KUDZ ZE KAYAH PROJECT

RESPONSE #3 TO YESAB EXECUTIVE COMMITTEE INFORMATION REQUEST KZK

June 2018

**FIGURE 3-1
 SURFICIAL GEOLOGY
 PROJECT AREA**

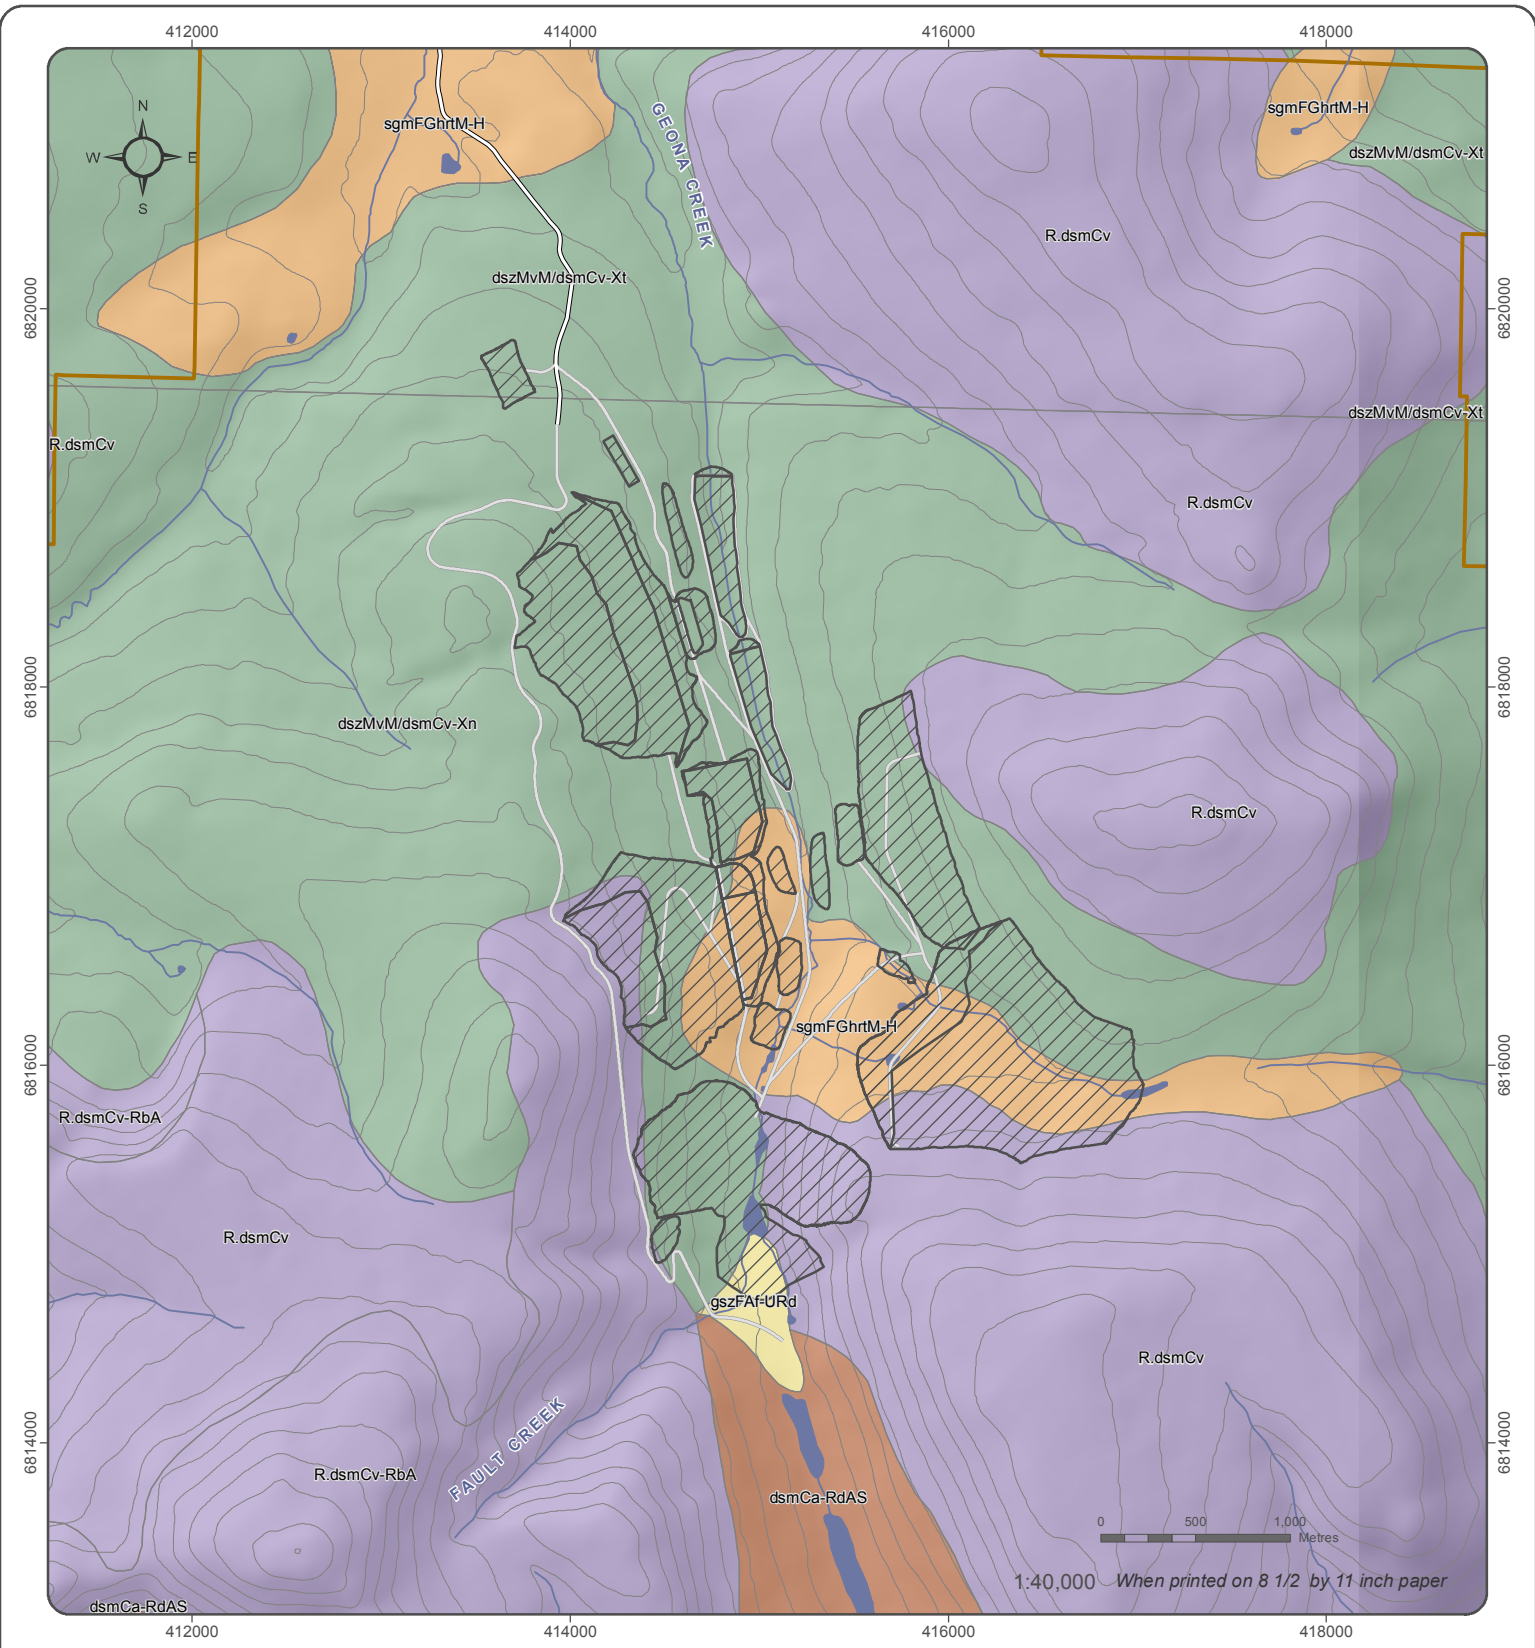
Provide a surficial geology map (1:10,000) for the footprint of the mine with the following:

- a) a description of the surficial geology elements;
- b) surface extent of glaciolacustrine sediments; and
- c) greater detail for surface and sub-surface extent and the thickness of glaciolacustrine sediments than what is currently provided in Fig. 11-2 [2017-0083-034-1].

During the adequacy review stage of the assessment process BMC provided YESAB with a Terrain Stability and Hazard Assessment Report (Appendix R2-H of Response Report #2) (BMC, 2017a). This report includes a description of the surficial geology elements, surface extent of till sediments and includes greater detail of the surface and sub-surface extent and the thickness of these sediments than what was provided in Figure 11-2 of the Project Proposal. For clarity this information is summarized below and illustrated in Figure 3-1. Figure 3-1 is at the scale of 1:10,000.

Figure 3-2: Example of Interstitial Placement

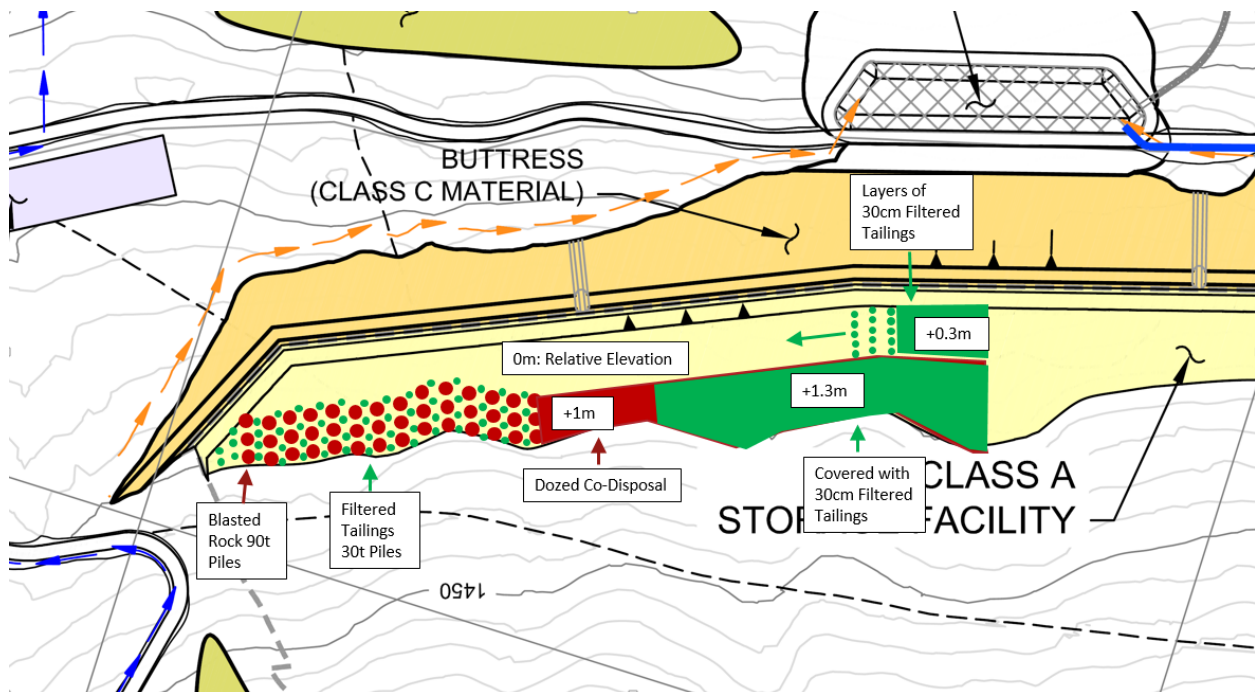
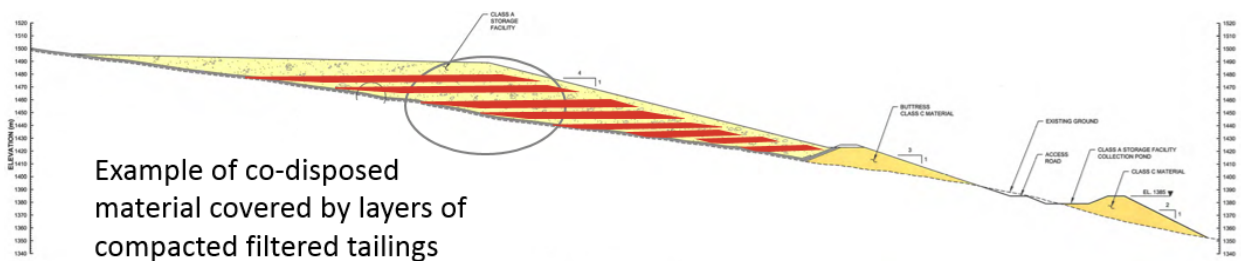
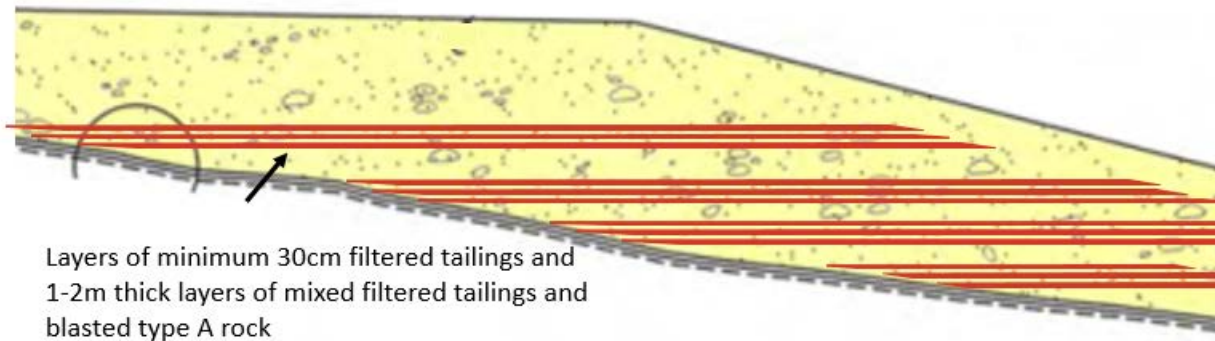
Once again this project has yet to fully define the type of technology to be used on a critical aspect of the mine. Depending on the type of liner to be used, different water quality issues downstream of the Class A Storage Facility can arise. Yukon Conservation Society (YCS) recognizes that technology and costs could change thus resulting in something other than vacuum filtration being used, however it does raise the issue of a radically different process being used. This process will not have gone through the YESAB assessment and could have impacts on the amount of tailings being created and/or the water being discharged from the Class A Waste Storage Facility.

2. Blasted waste rock will be dumped in piles on a flat area, alternating with filtered tails at a ratio so that when dozed together they will mix and form a high compaction co-disposed layer.
3. Filtered tailings will be placed in 30 cm compacted lifts, between these layers, and always on the external faces of the storage facility (side slopes and upper slope surface).

The method is illustrated in plan view in Figure 3-2 and section view in Figure 3-3 and Figure 3-4.

**FIGURE 5-1
CASSIAR BEAR MANAGEMENT UNIT
AND GAME MANAGEMENT
SUBZONES BOUNDARIES**

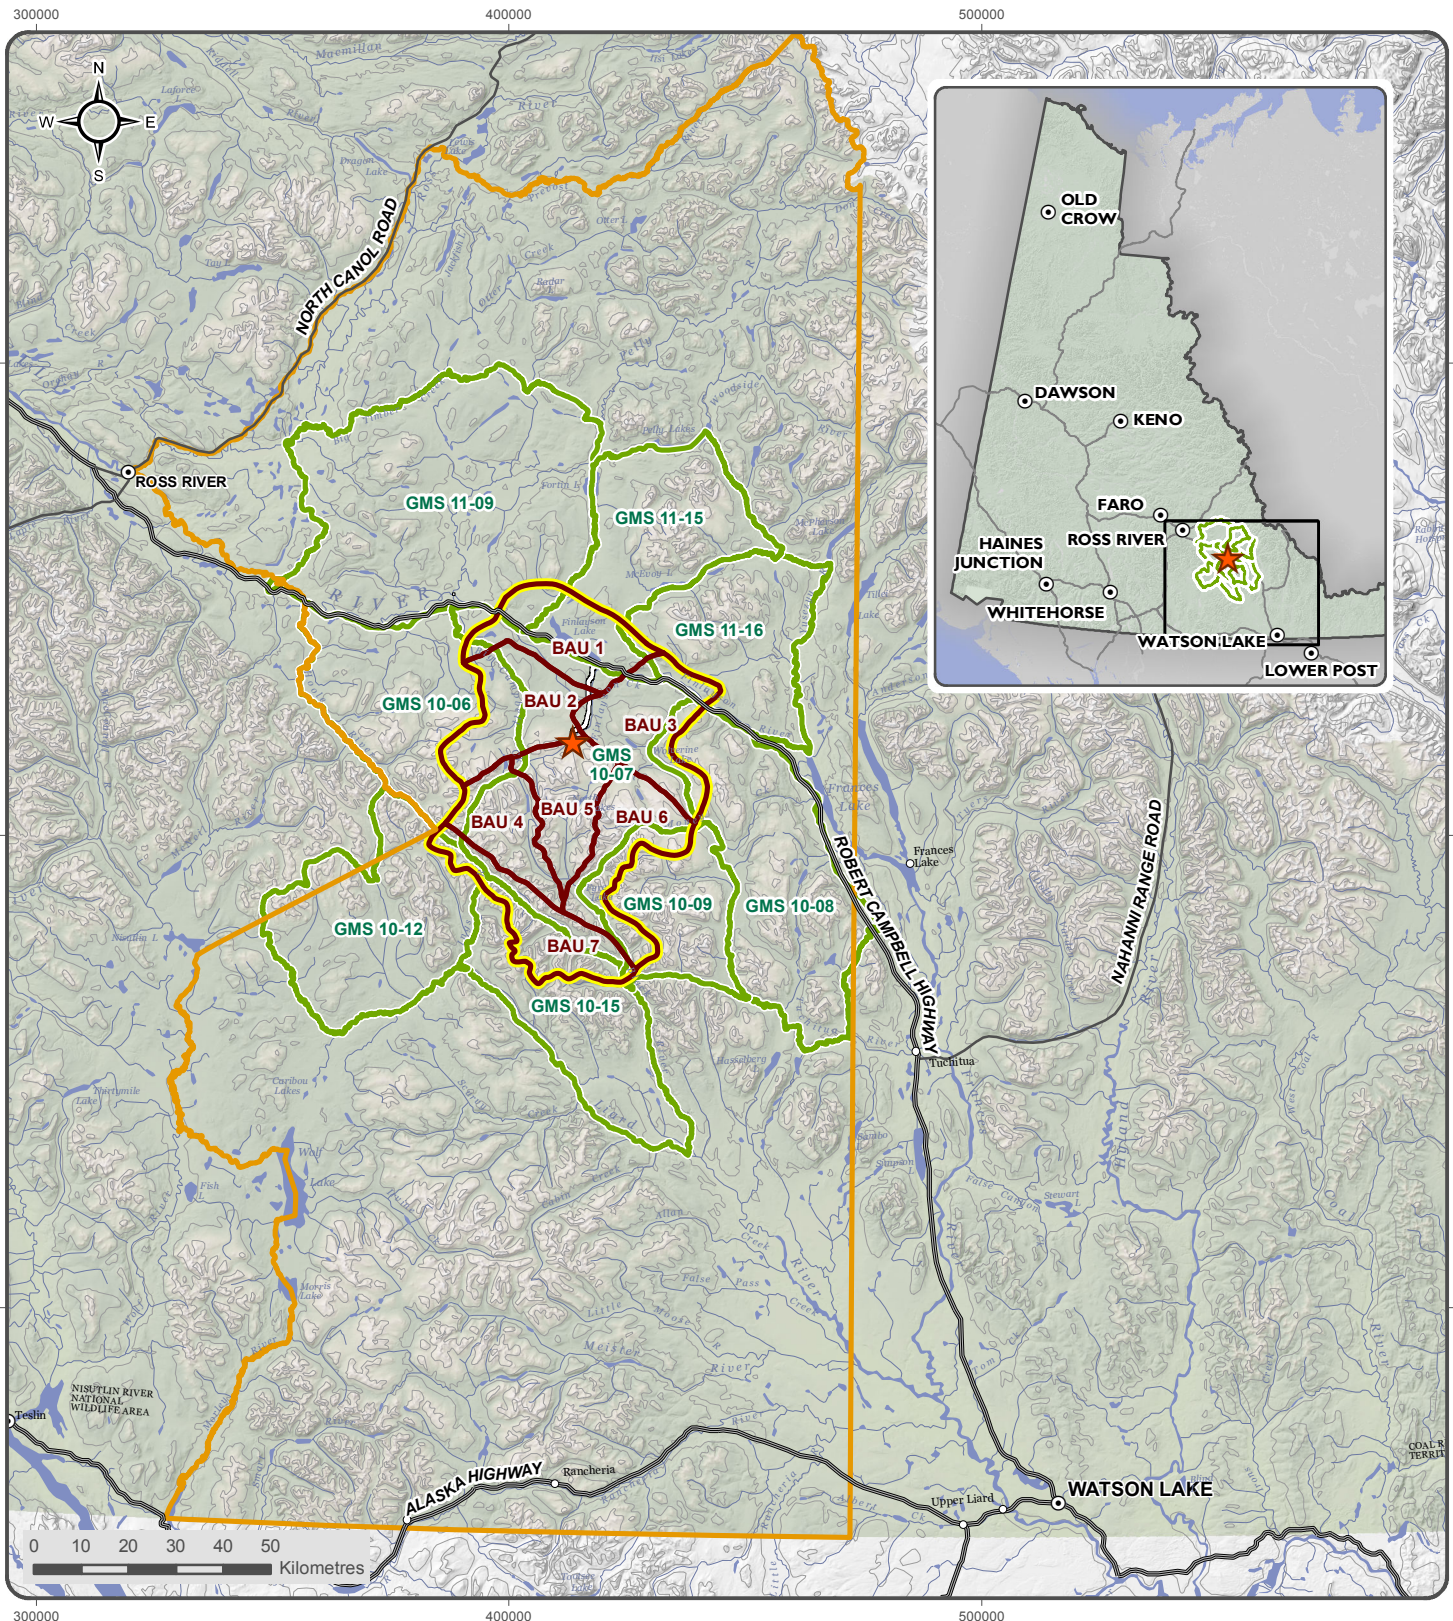
Provide maps at an appropriate scale that show modeling of security (including core security areas) and linkage zones.

Following further discussions with Yukon Government, the mortality rates for all GMSs that surround the Project were combined to further assess the average mortality rate. These GMSs included GMS 10-06, 10-07, 10-08, 10-09, 10-12, 10-15, 11-09, 11-15 and 11-16; as shown in Figure 5-1. The total combined area for these GMSs is 13,546 km². The combined mortality for these GMSs between 1995 and 2017 is 47 bears (13 female and 34 male) (Table 5-3). Of these, 43 bears were killed by harvest and four bears killed by other means. The average number of bears killed per year between 1995

and 2017 is 2, or 1.1% of the population. Female mortality for this period was 0.6% of the female population and male mortality was 1.5% of the male population. GMS 10-07 had the highest mortality pressure with a total of 17 bears killed over that period, whereas most other between one and seven bears were killed.

**FIGURE 6-1
FISH HABITAT AFFECTED BY
PROPOSED MINE DEVELOPMENT**

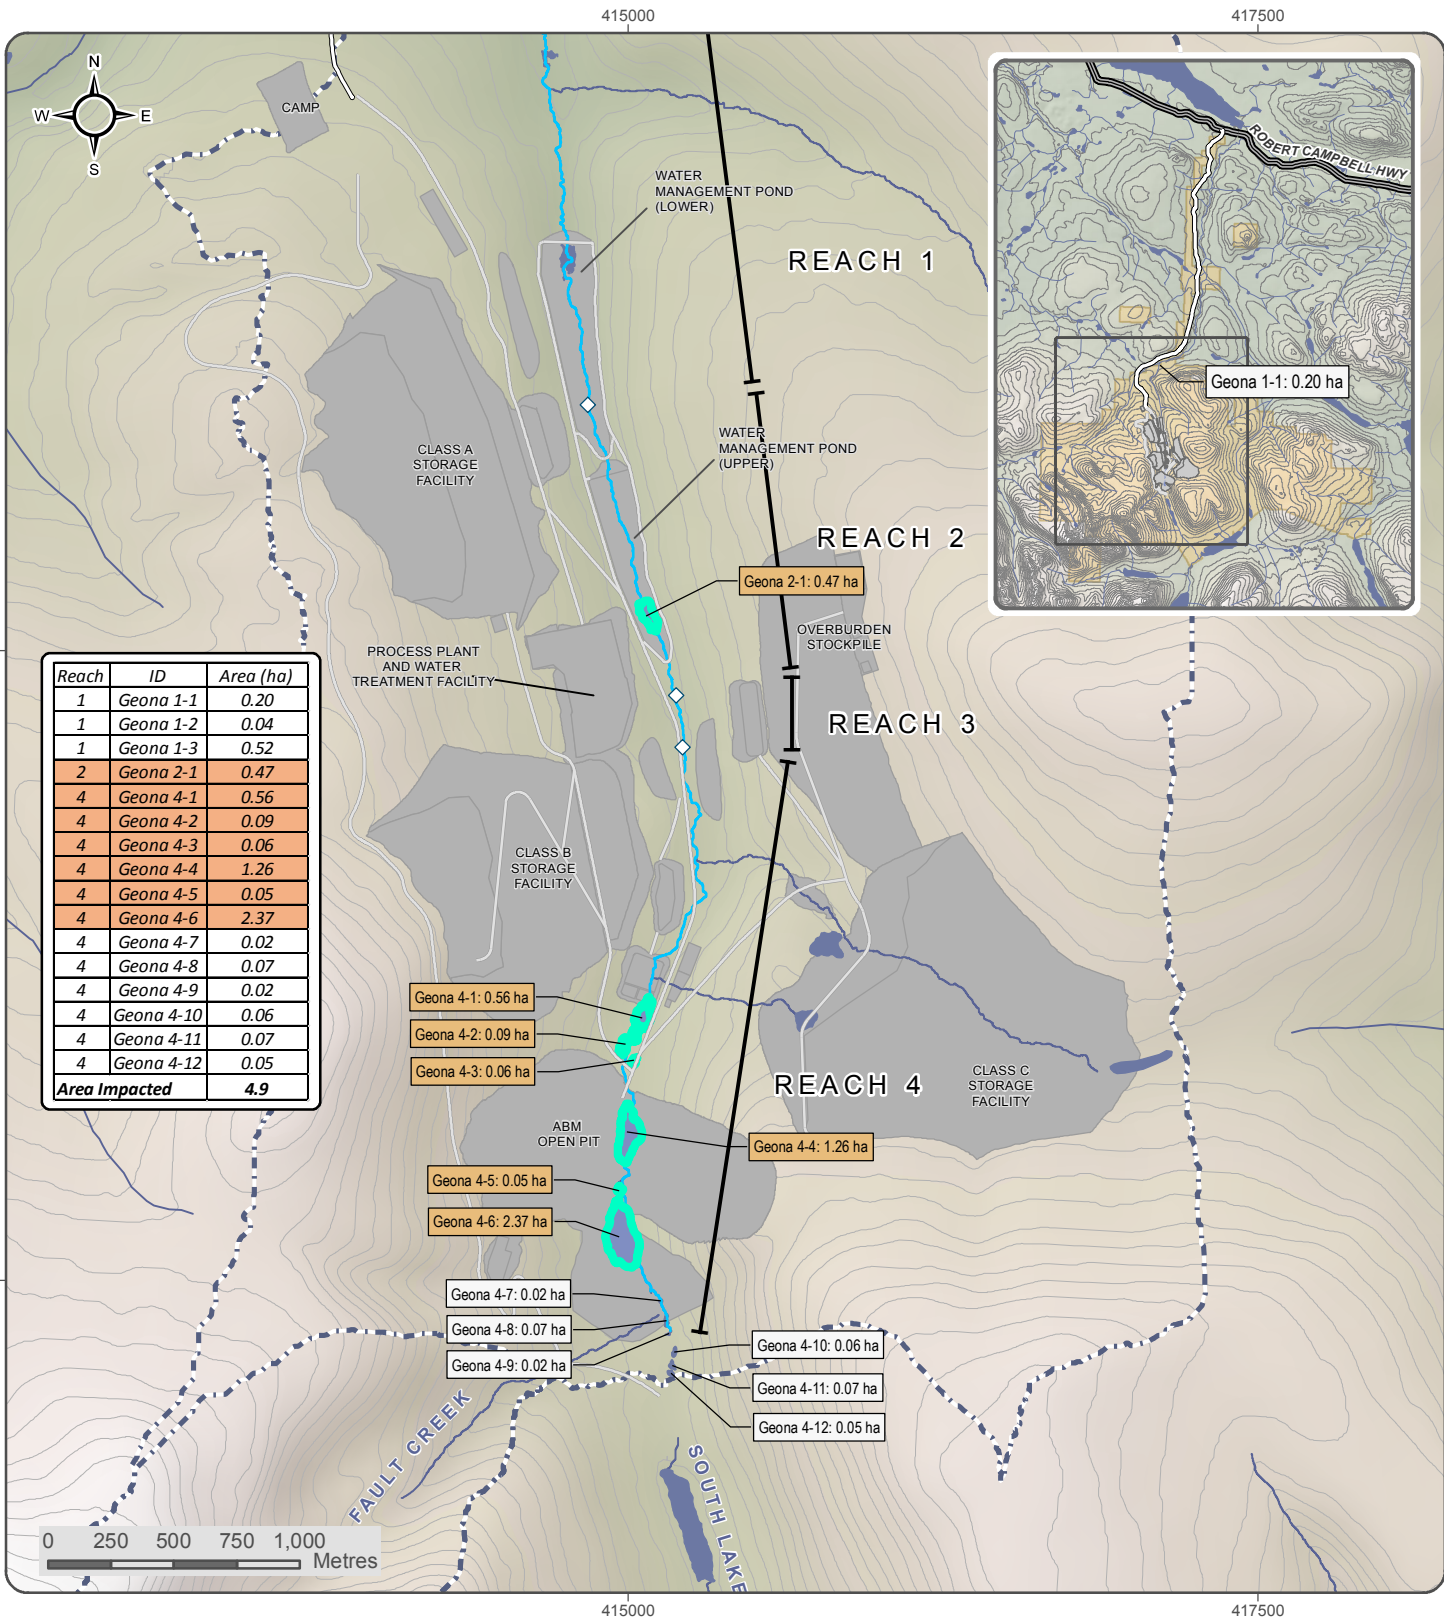
Pertaining to the proponent's plan involving restoration of fish passage for the Robert Campbell Highway culvert crossing of Finlayson Creek, sufficient baseline data will be required to demonstrate that the proposed offsetting measure is actually an offsetting measure.

Provide information on the types and amounts of fish habitat to be made accessible by the restoration of fish passage for the Robert Campbell Highway culvert crossing of Finlayson Creek and a habitat assessment of areas of stream habitat to be made accessible.

The proposed Project is estimated to result in the loss of approximately 5.4 km of fish habitat in Geona Creek, covering an area of 15.35 km², which cannot be avoided (Figure 6-1; Table 6-1). An additional 4.85 ha of wetland/pond habitat in the headwaters of Geona is also predicted to be lost.
